TECHNICAL BULLETIN

FAM-A-0091-C

Production Discontinuation of the FX3G Series

■ FX3G

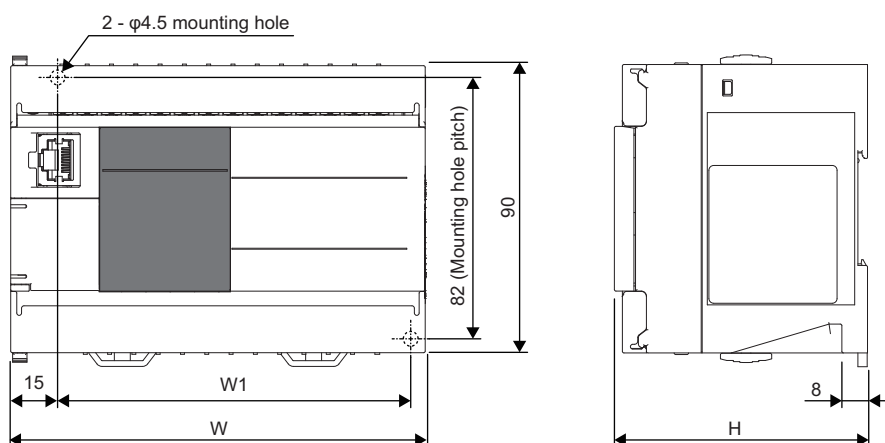
Model	W	W1	H
FX3G-14/24M□	90	82	86
FX3G-40M□	130	122	86
FX3G-60M□	175	167	86

■ FX5UJ

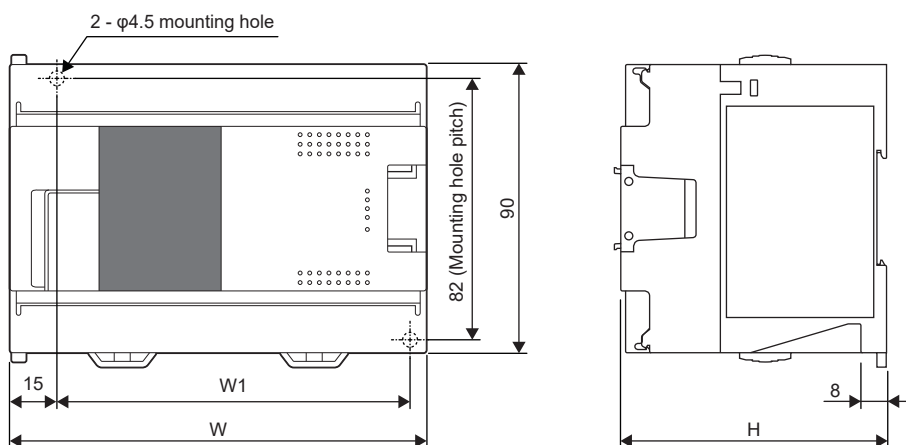
Model	W	W1	H
FX5UJ-24M□	95 (+5)	76 (-6)	83 (-3)
FX5UJ-40M□	130 (±0)	111 (-11)	83 (-3)
FX5UJ-60M□	175 (±0)	156 (-11)	83 (-3)

Dimensional differences from the FX3G are shown in parentheses ().

■FX3GC

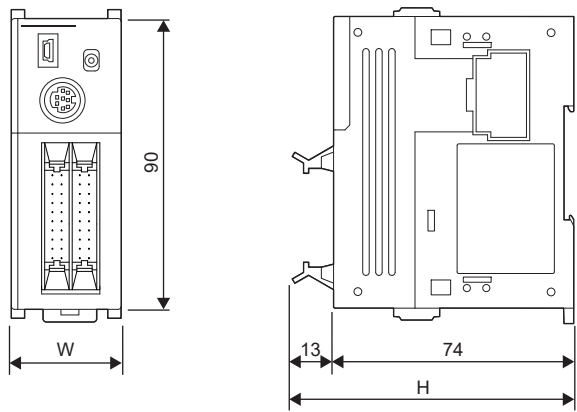
Model	W	H
FX3GC-32MT/D□□	34	74 + 13 = 87

■FX5UC

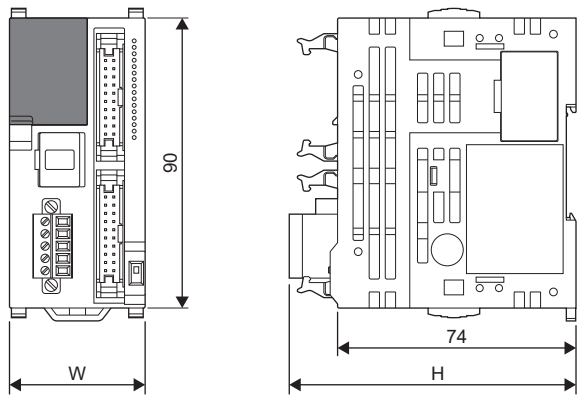
Model	W	H
FX5UC-32MT/D□□	42.1 (+8.1)	89.1 (+2.1)

Dimensional differences from the FX3GC are shown in parentheses ().
